Beacon Solar, LLC's)
Application for Certification of the) Docket No. 08-AFC-2
Beacon Solar Energy Project)
_____)

BEACON SOLAR, LLC'S REBUTTAL TESTIMONY

AMENDED APPLICANT'S EXHIBIT LIST - BY TOPIC AREA

FIGURE R-3

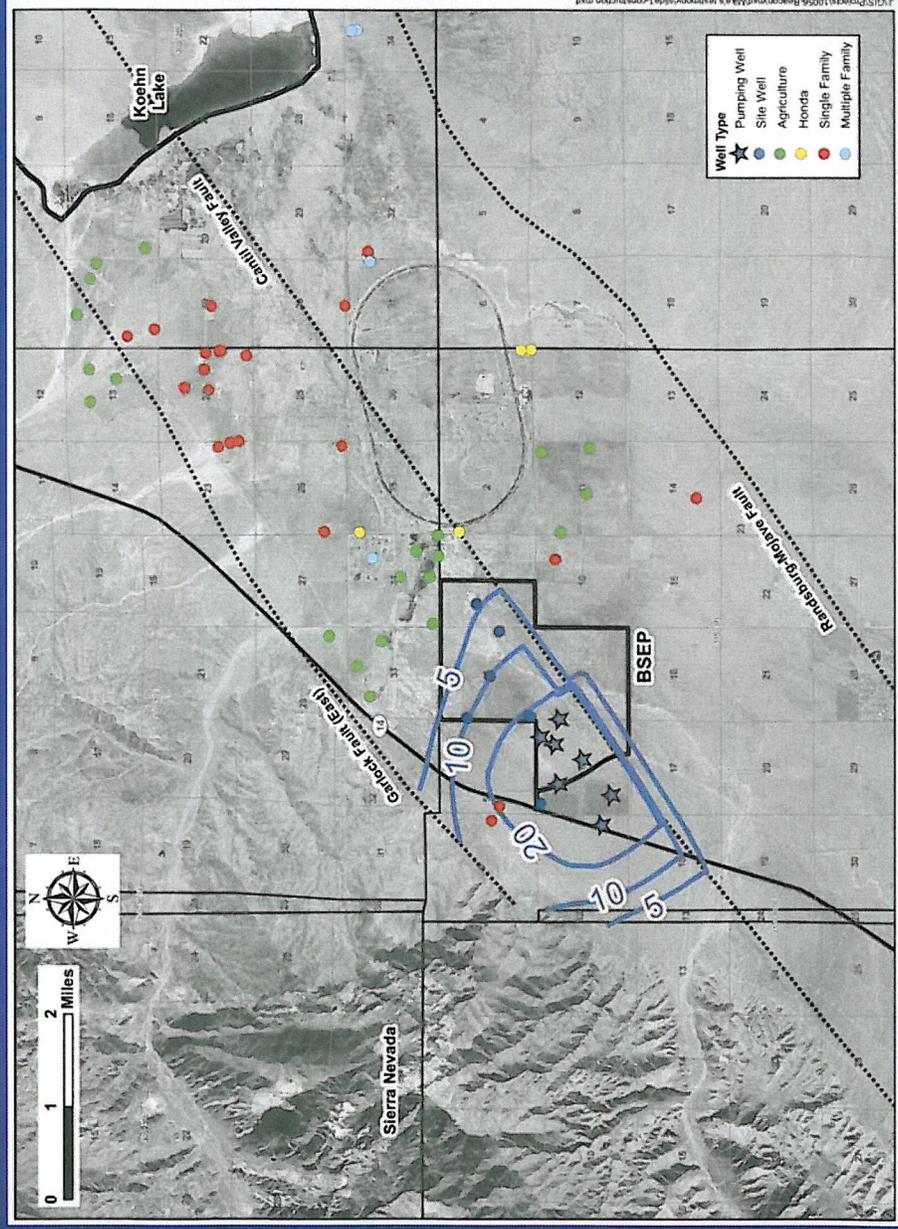
Figure R-3 is the output from the numerical groundwater model showing the potential impacts at the end of the construction period. It shows the difference between the “No Project” and Project pumping, and as such defines the area and wells that should be considered for monitoring during construction. As shown those wells that are only immediately adjacent to the site should be considered. As discussed in Soil and Water Condition-1, a well canvas would be conducted to identify all wells within this area and their status as operational or abandoned or destroyed, and the operational wells in this area would be included in the monitoring program.

Figure R-3 shows the expected drawdown at the end of the construction period with well pumping to produce the volume estimated in the FSA at 8,086 acre-feet. Under either scenario, the model results show that the possibility of significant impact to surrounding wells is minimal. The conditions provided in Soil and Water-1 stipulates the protocols for the evaluation and mitigation of impacts during construction pumping. These protocols ensure that there will be no significant impacts during proposed construction pumping, even if the pumping level assumed in the FSA were to occur.

FIGURE R-4

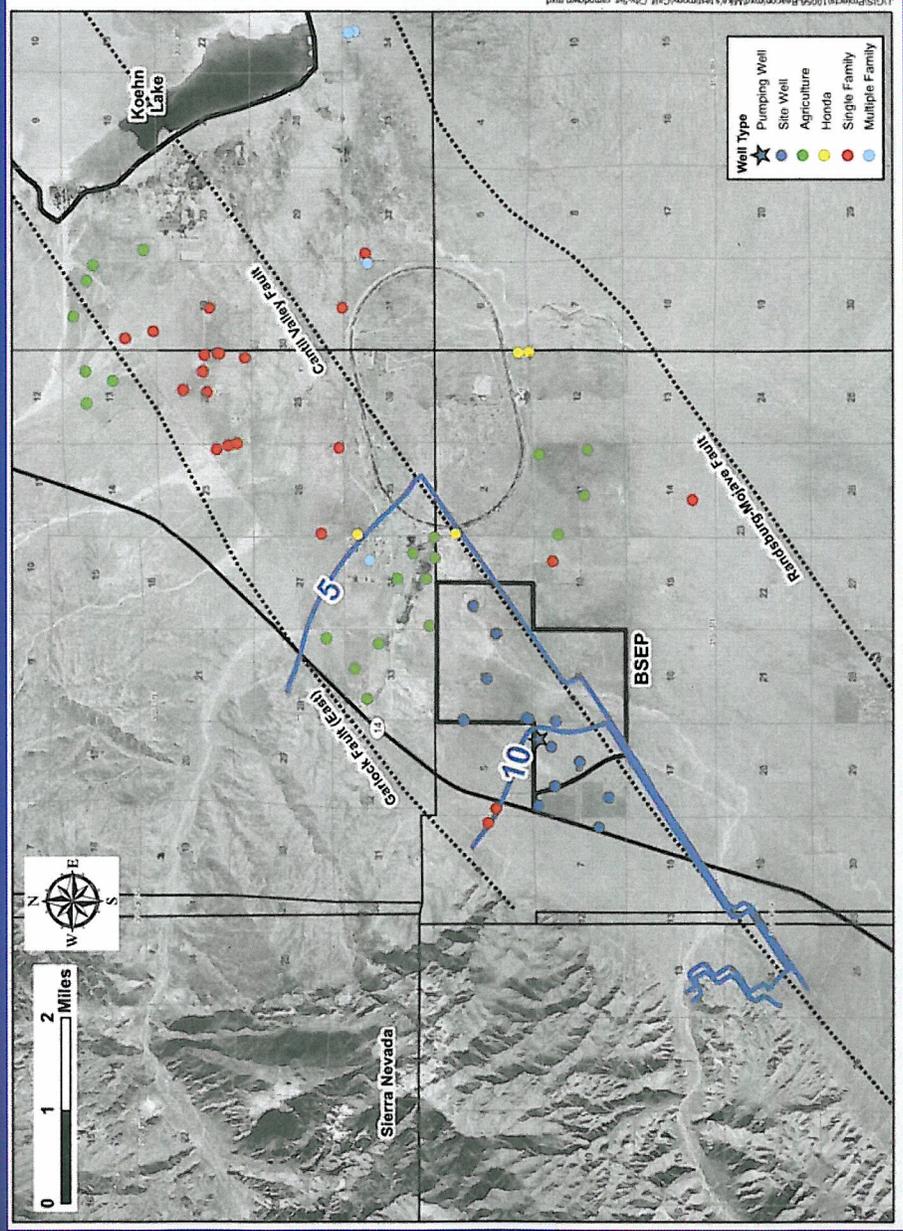
Figure R-4 is the output from the numerical groundwater model at the end of the first 5 years of pumping following construction under the California City option, whereby groundwater pumping would systematically be reduced to 153 acre-feet per year at the end of 5 years. Figure R-5 is the output from the numerical groundwater model at the end of 30 years of operation. A comparison shows a significant reduction in the number of wells that should be in the monitoring network. In fact, no offsite wells should be monitored at 30 years. And potentially no offsite wells could be affected by a difference of 10 feet or more 5 years after construction. These data would suggest that similar to the review of the monitoring program under the Rosamond option, the California City option should receive a serious review for need to continue beyond 5 years.
